**From:** Tracey Carroll  
**Sent:** Tuesday, December 11, 2012 9:58 AM  
**To:** Heckman, Lee  
**Subject:** CD-2012-0021 aka 211 S. Lamar Blvd.

RE: 211 S. Lamar Blvd. Planned Unit Development Assessment;  
Item 91 on Austin City Council's Agenda for December 13, 2012

### 3. Land Use Plan Comments – Sheet 1

LAND USE PLAN

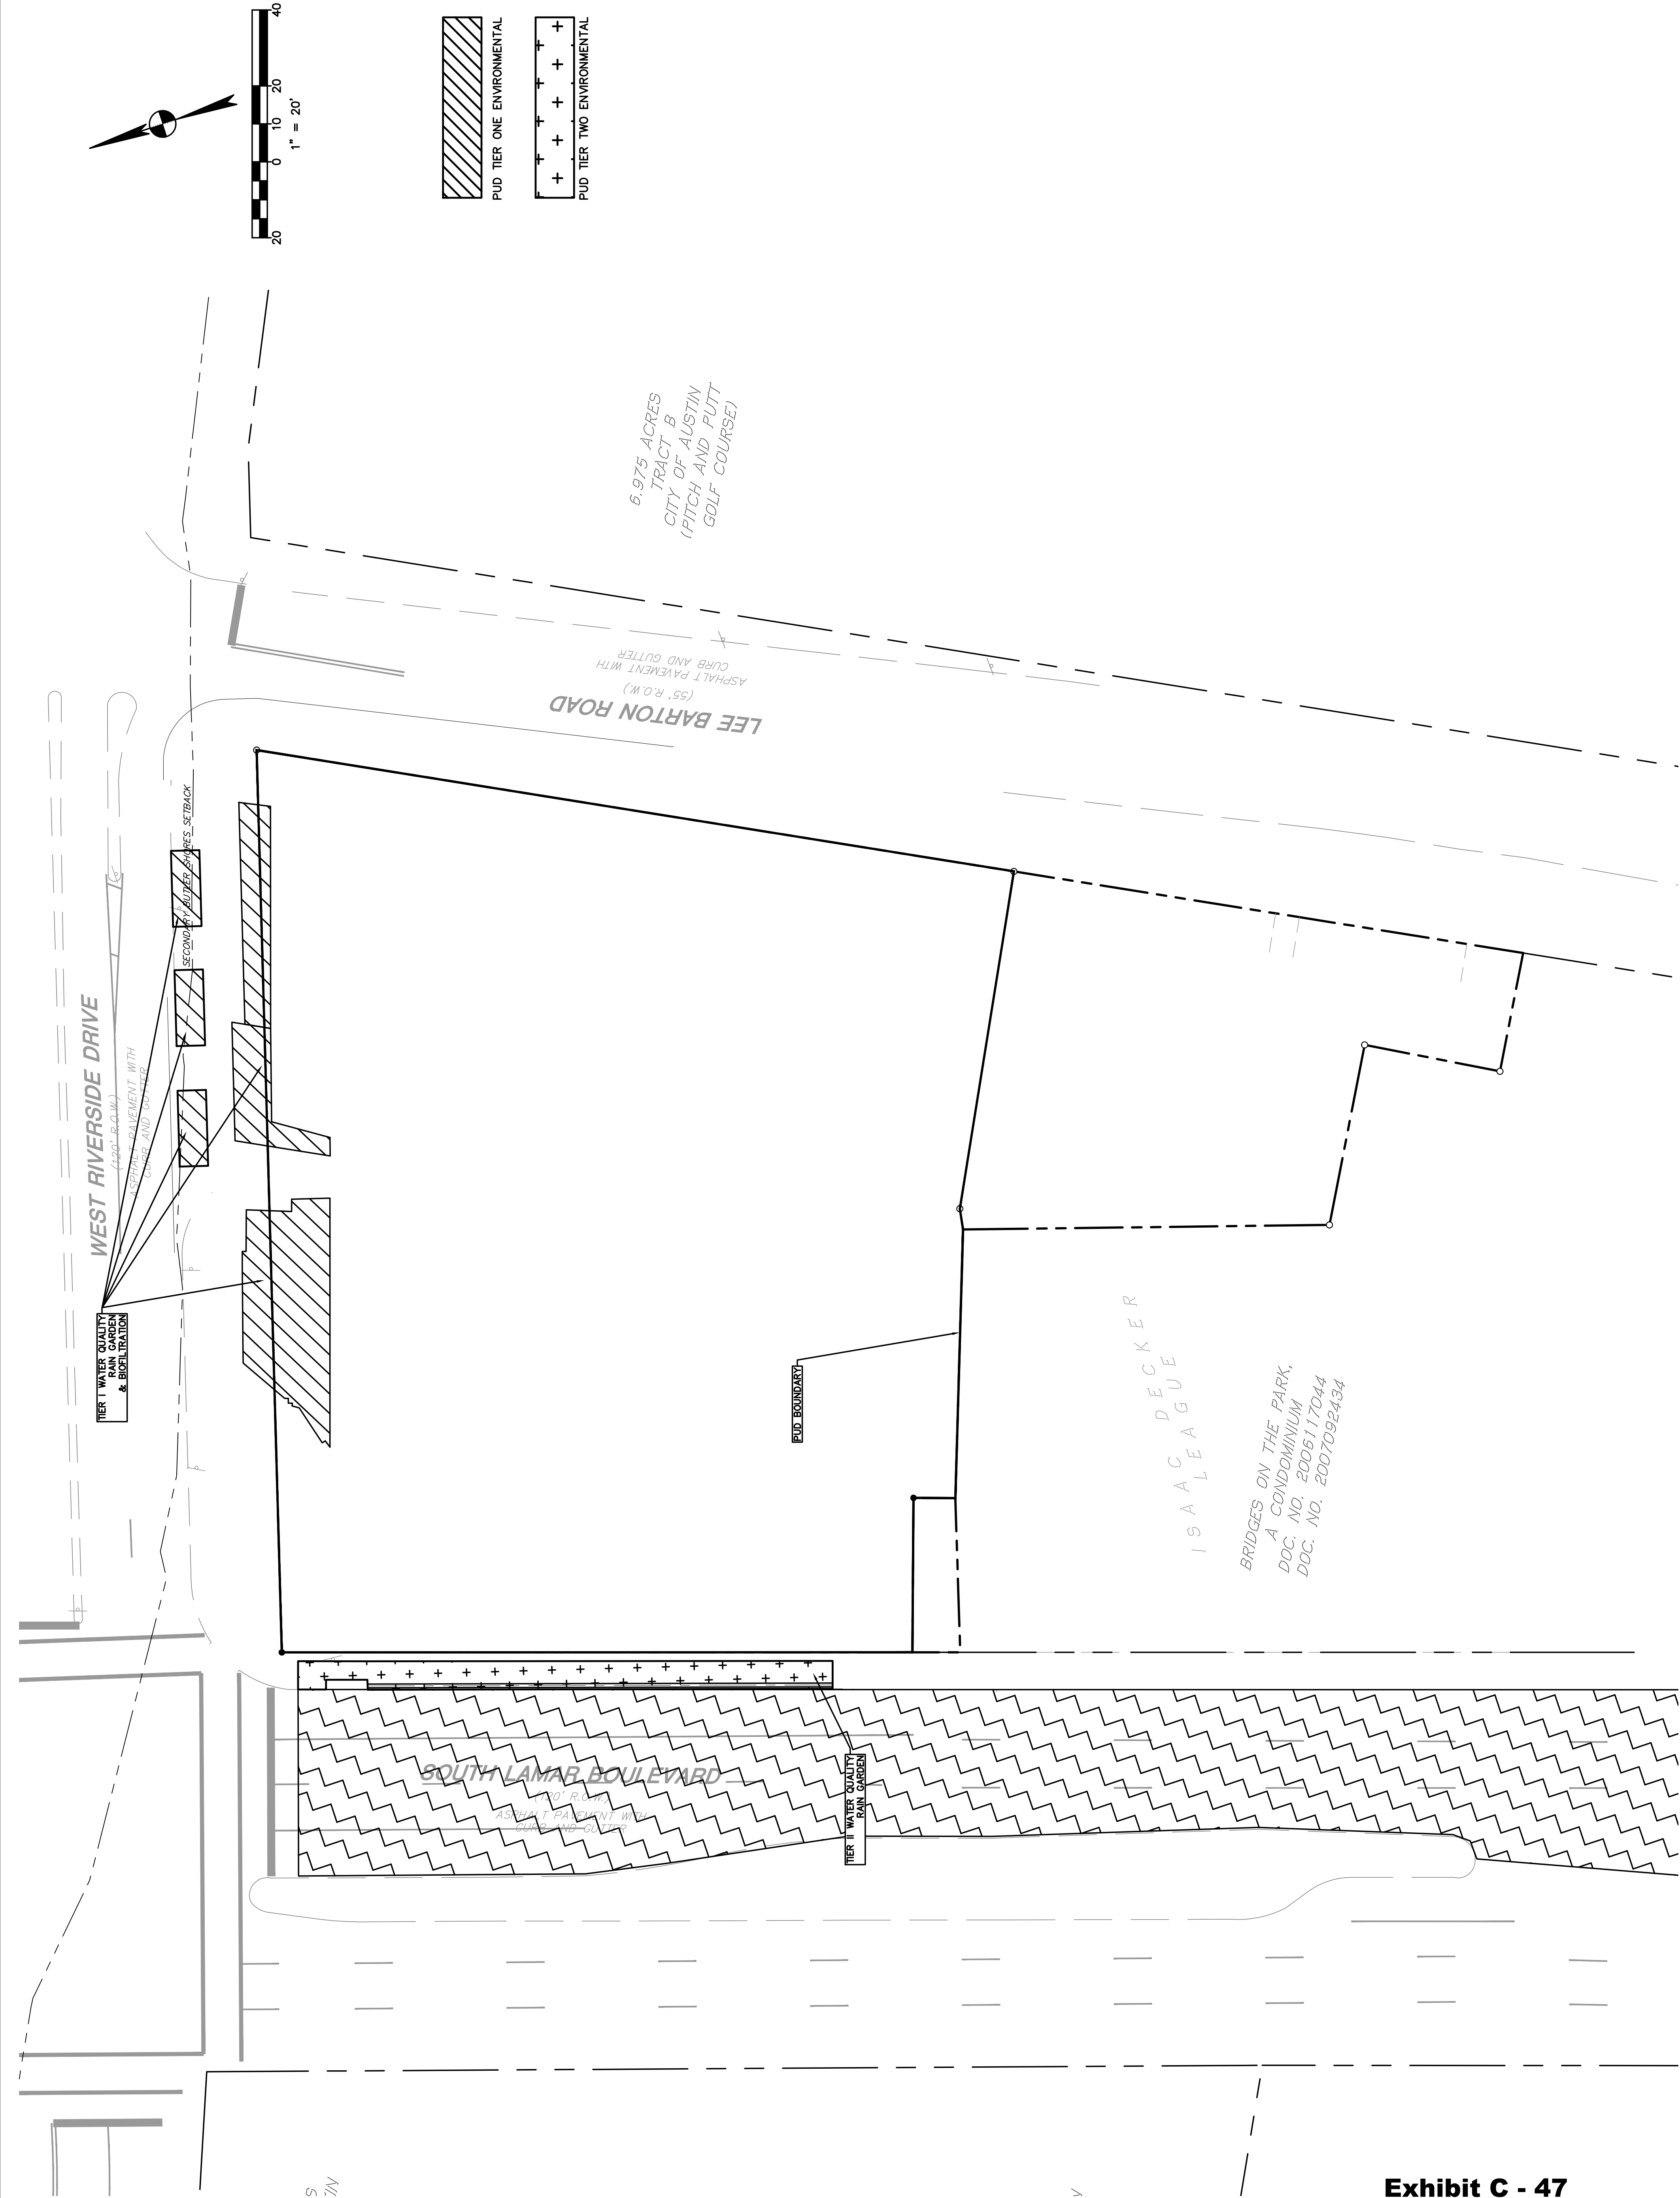
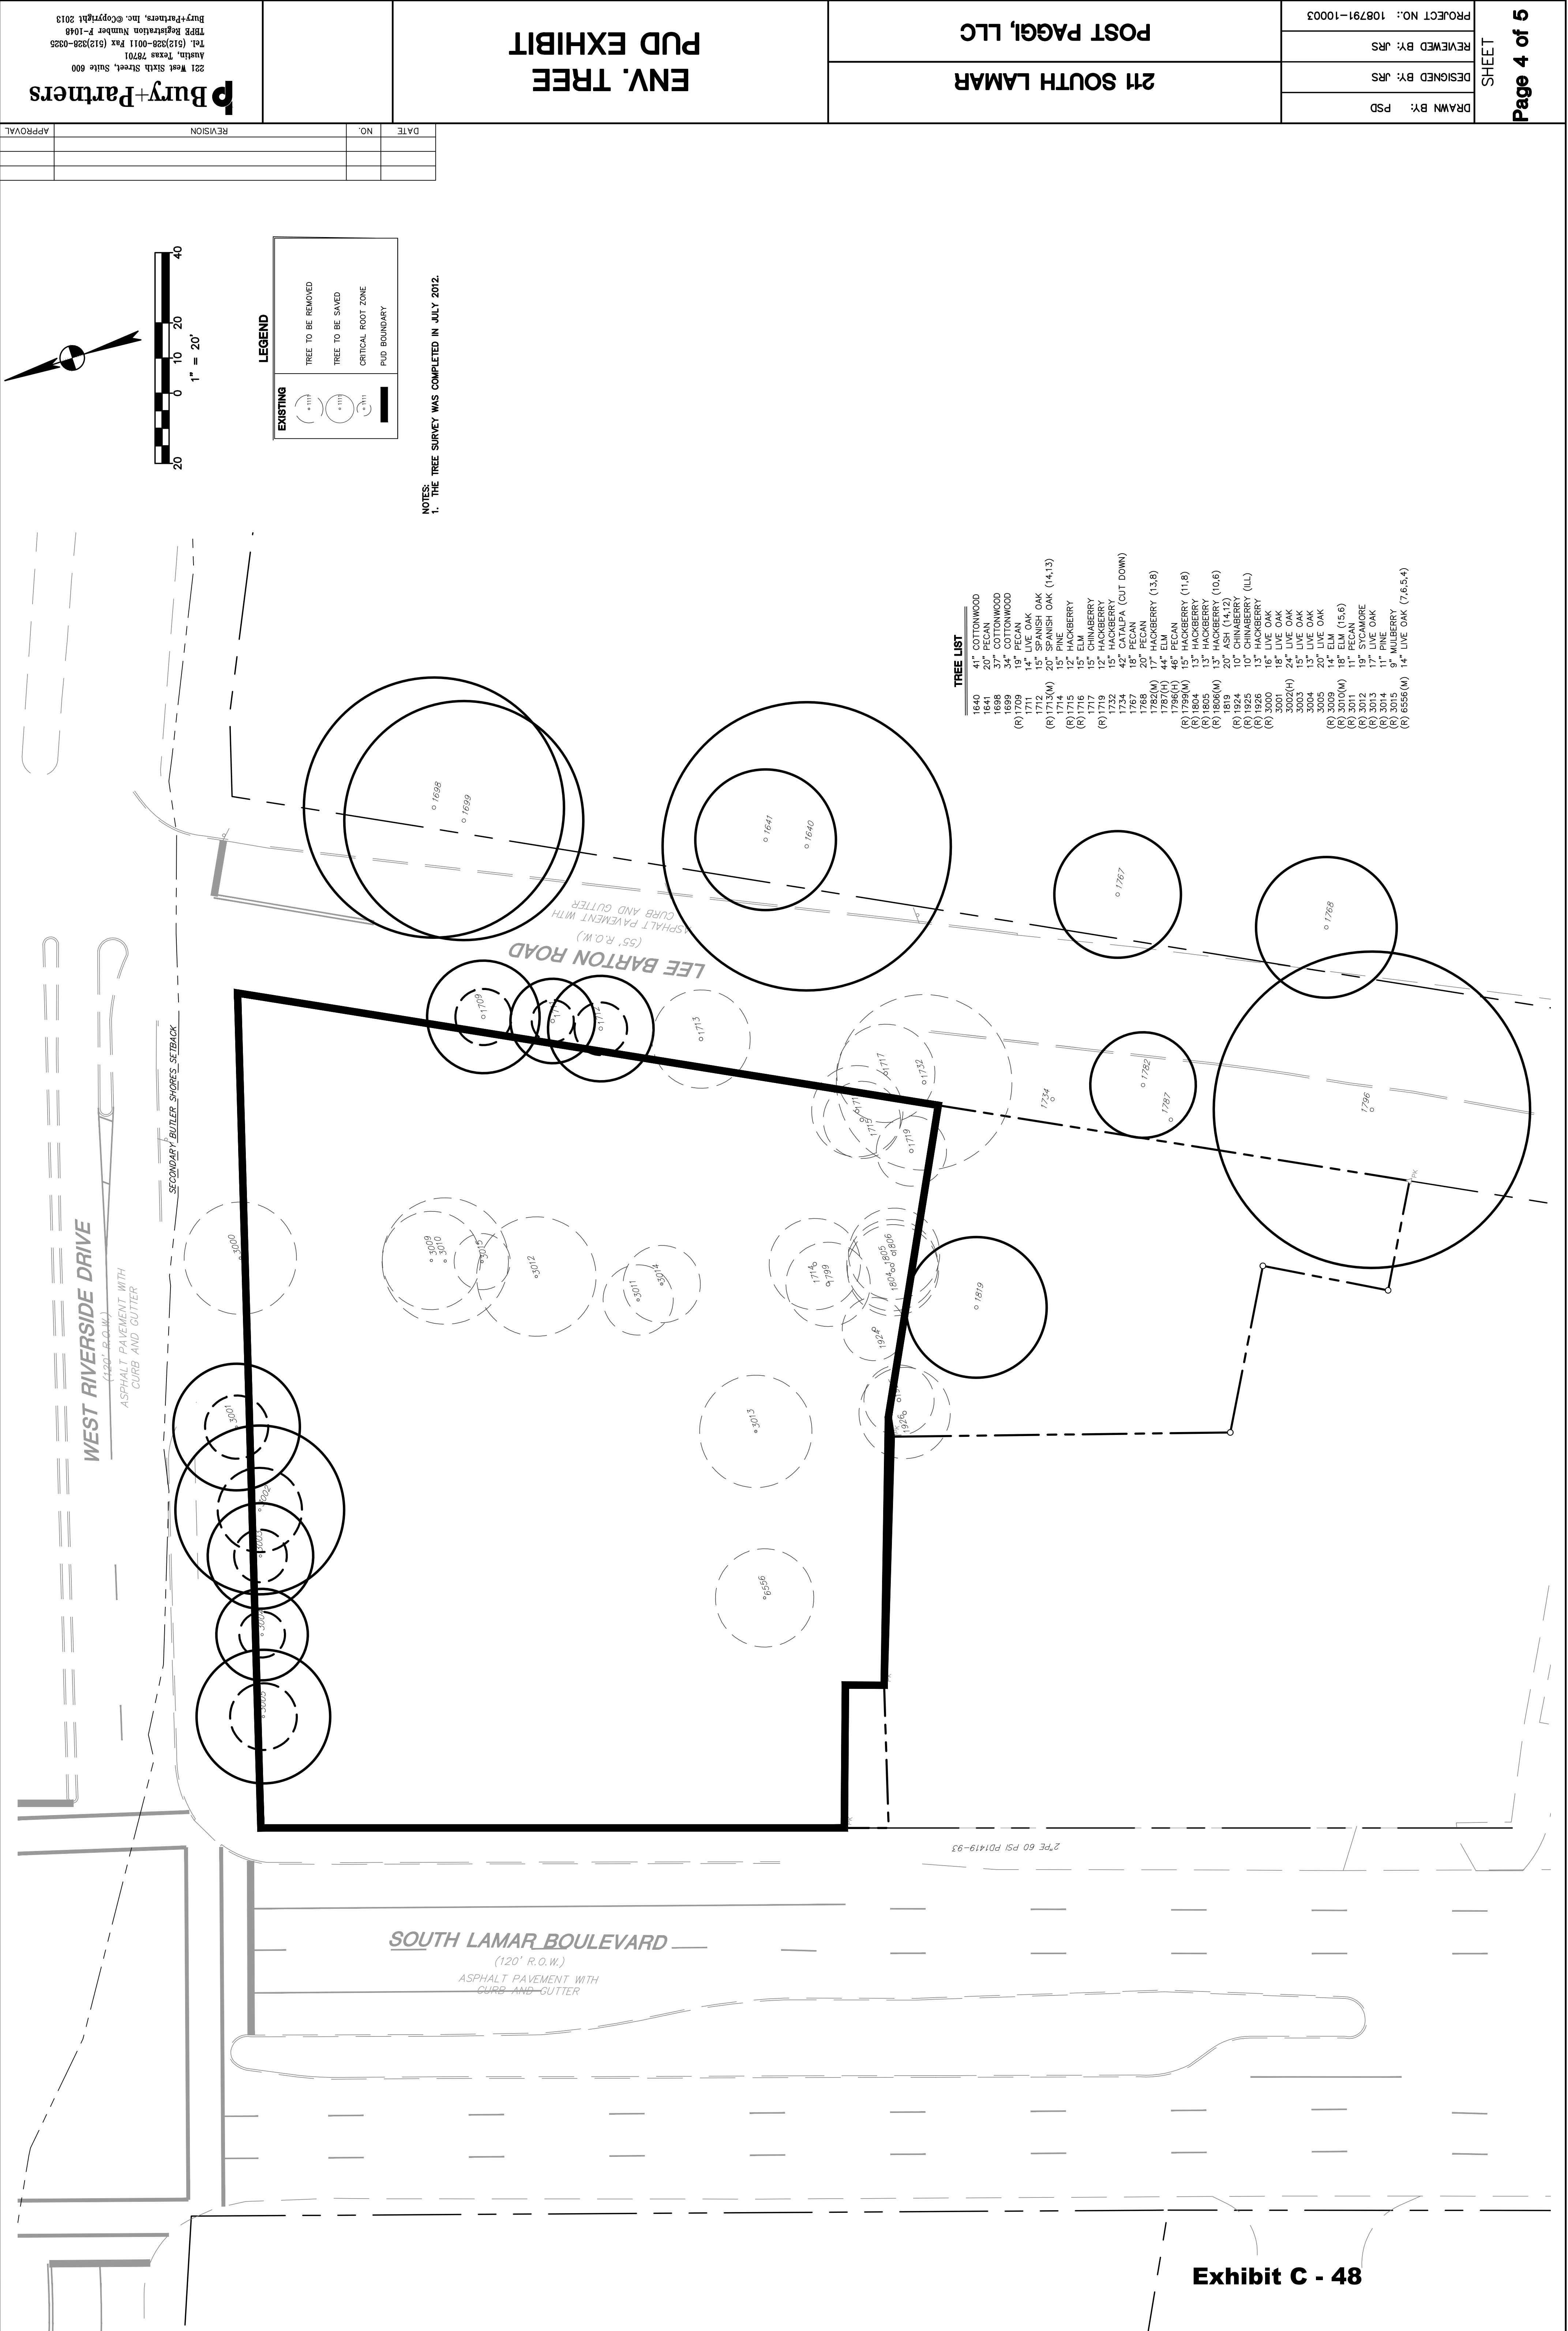
### 4. Land Use Plan Comments – Sheet 2

- h. Note # 32: Please highlight trees in Sheet 1 schematics. See also 6a, below.
- i. Note # 33/Variance to TCM9.3.0 #3: Is this a variance to zoning requirements or to site-planning requirements? If it is appropriate to consider at the rezoning stage, then provide the documentation from Transportation (see reviewer note #7) concurring with the proposal. If this is NOT a variance to the zoning code, but associated with site-planning, then please remove from plan sheet and table of CS variances.

- i. The Land Use Plan has been revised to remove color depictions and is now black-and-white.**
4. Land Use Plan Comments – Sheet 2
- a. As noted above, please be consistent with items noted in the Tier Tables. If something is specified, quantified, qualified, or otherwise elaborated upon in one, please do so in the other. Note: Some of these plan notes may be incorporated into the PUD document instead of, or in addition to, being on the plan sheet. Specificity matters.

- g. **Noted.**
- h. Note # 32: Please highlight trees in Sheet 1 schematics. See also 6a, below.
- h. **A new sheet has been added to the Land Use Plan clarifying tree preservation.**
